ADDENDUM NUMBER FOUR, Page 1

Building Remodel
PAPÉ PROPERTIES INC.
Cosmopolis, Washington

April 26, 2024

This addendum is issued for the purpose of clarification and/or revision of the Project Manual and/or Drawings. This addendum includes the following items:

project number	22-22
date	4.25.24
file name	BID A213-Add 4
drawn by	ACG
title	Guard Rail & Additional Bollard Locations
	Addendum #4
1	of 1

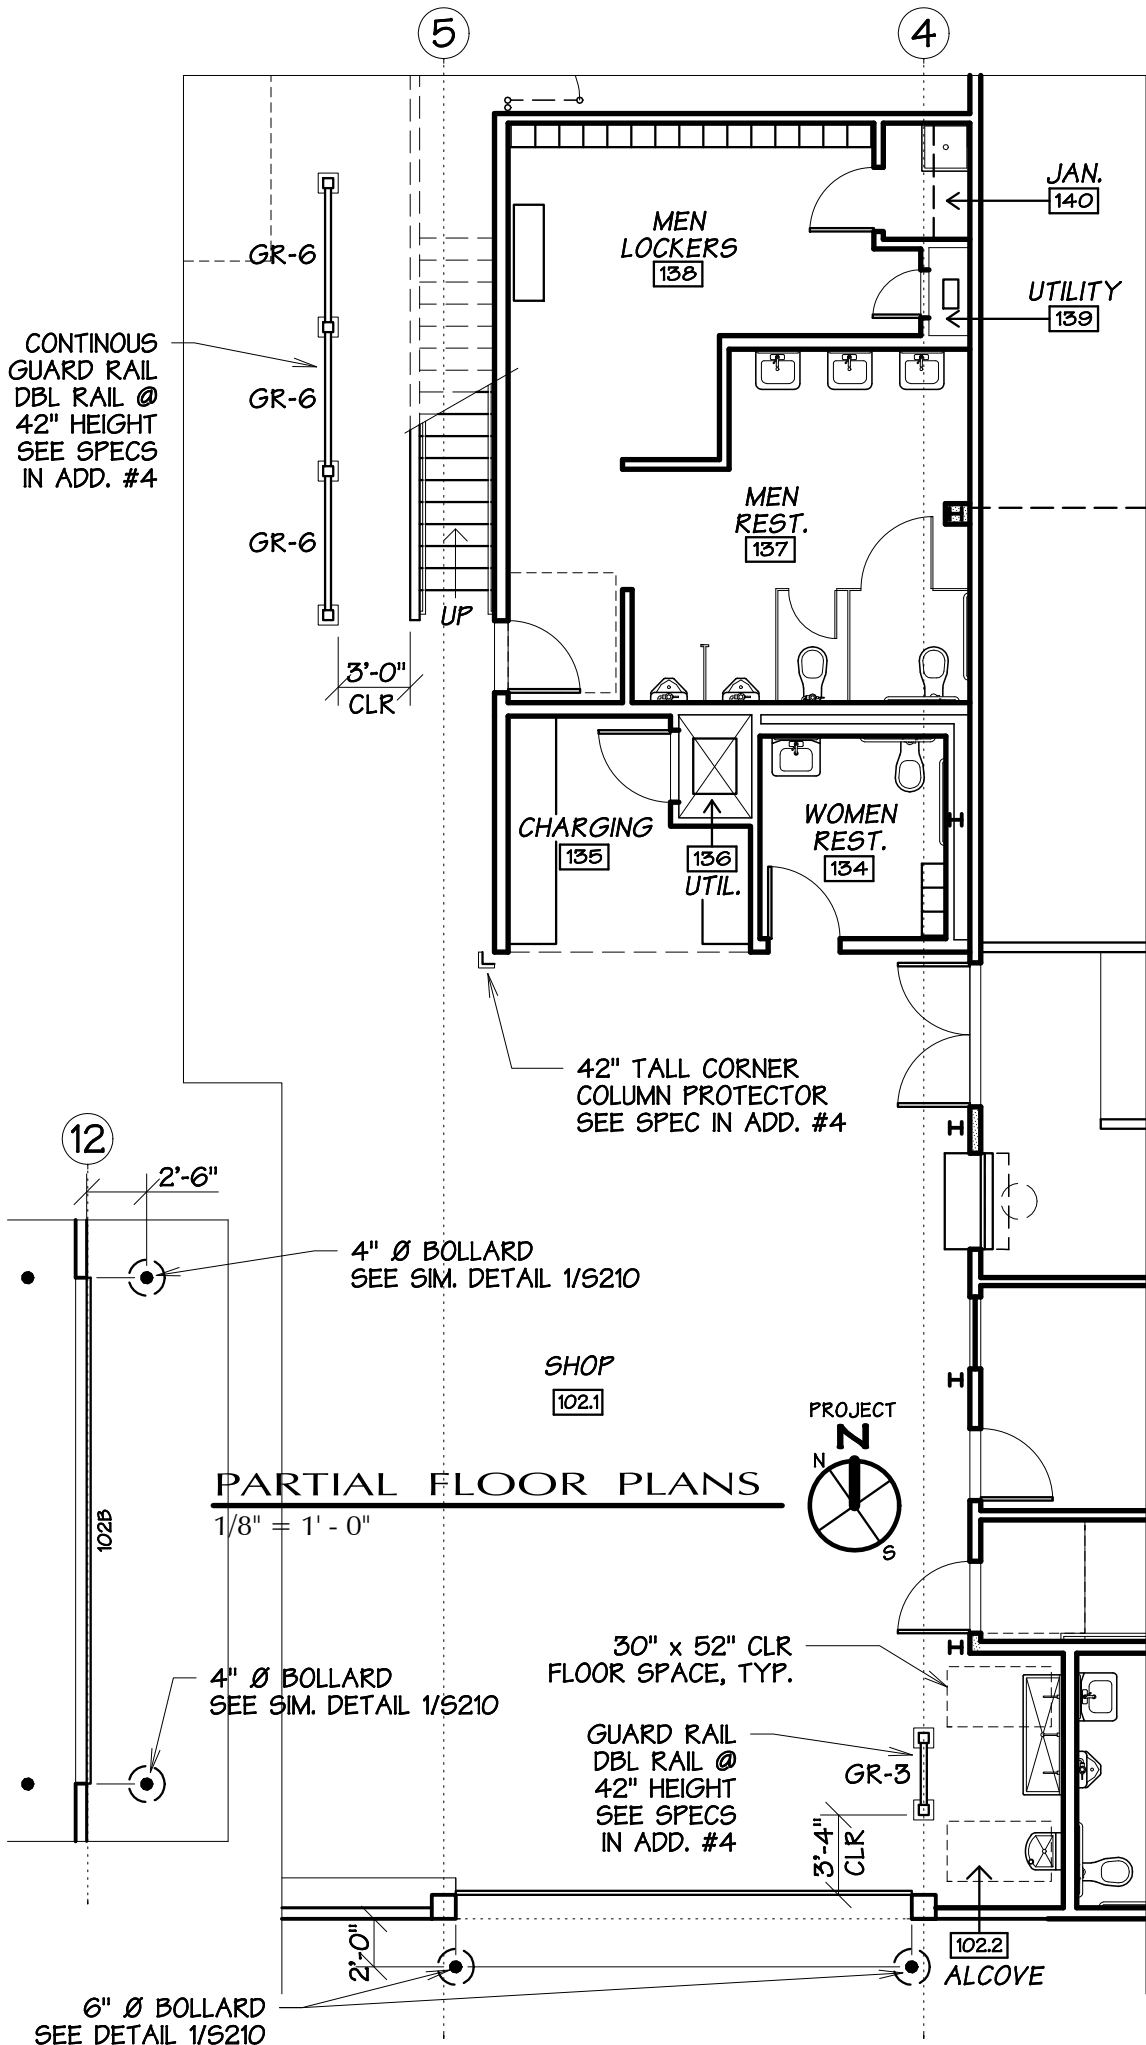
- E. Sheet S210, Foundation Plan & Notes
Provide guard rail and additional bollard locations shown on attached Drawing 1 of 1.
Delete bollard shown on south exterior side of Equipment/Storage-104

LOWER FLOOR - ELECTRICAL - DEMO

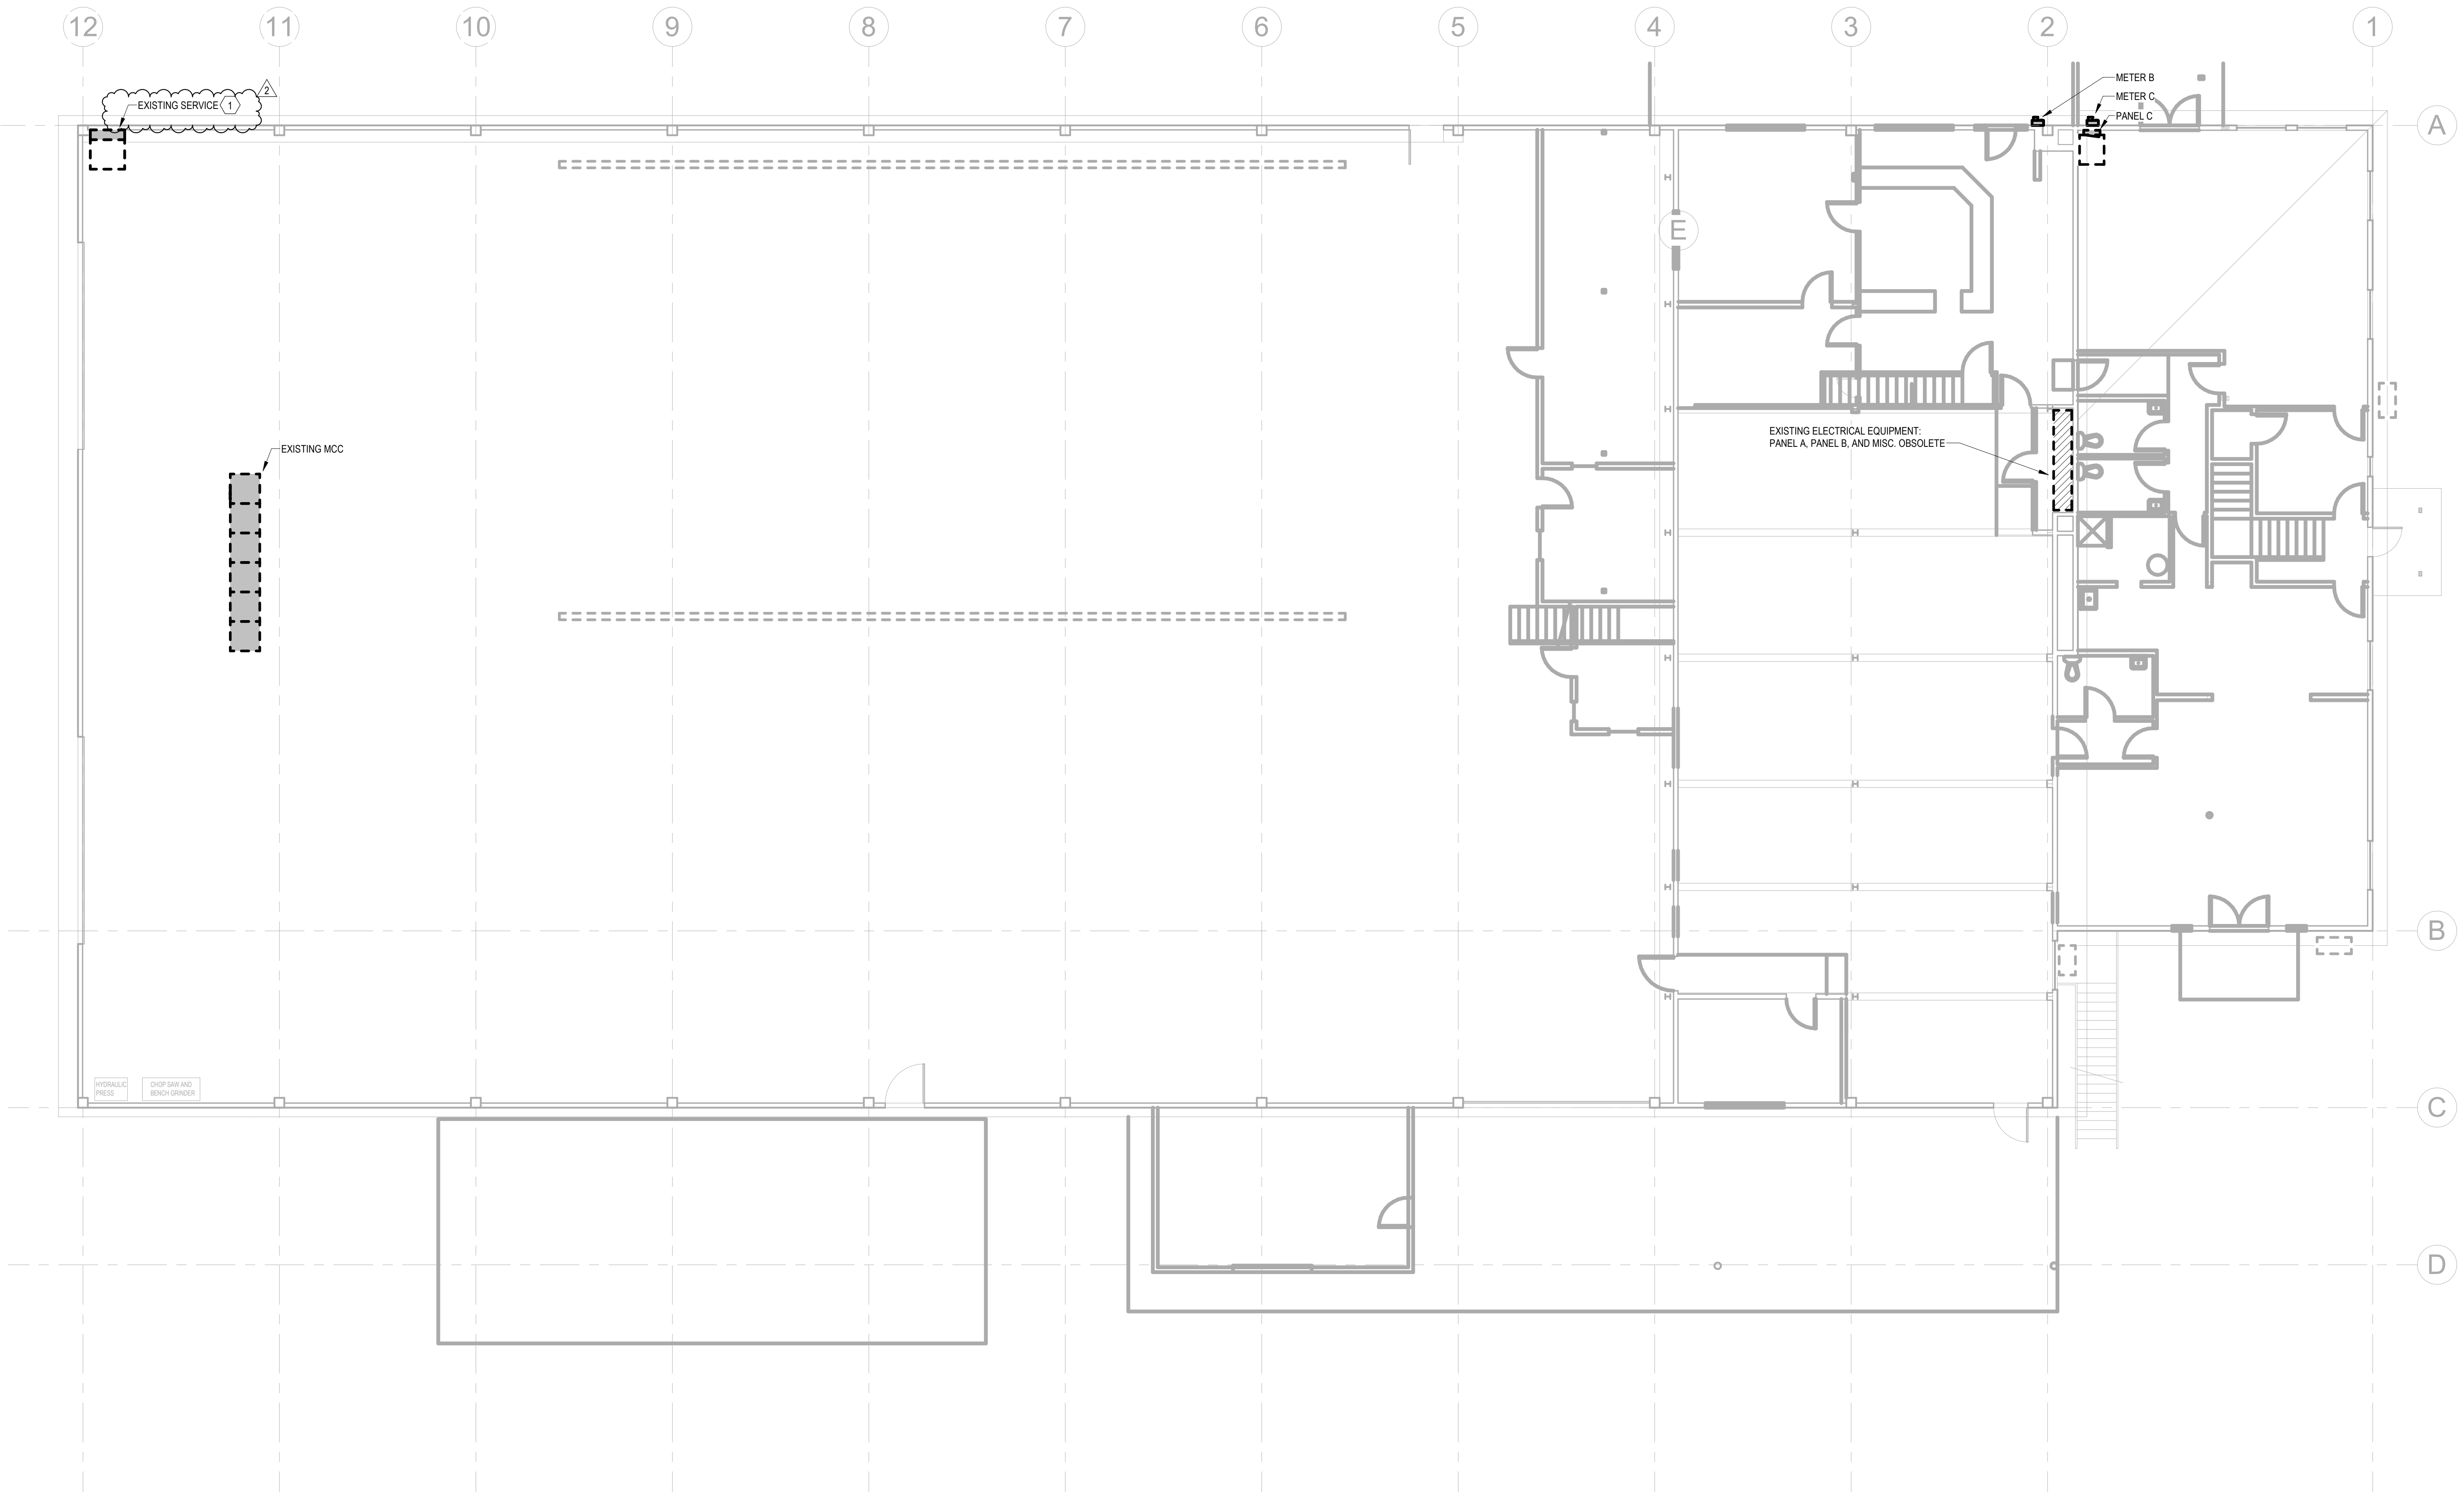
- F. See attached revised Sheets E001, ED201, E201 and E202.
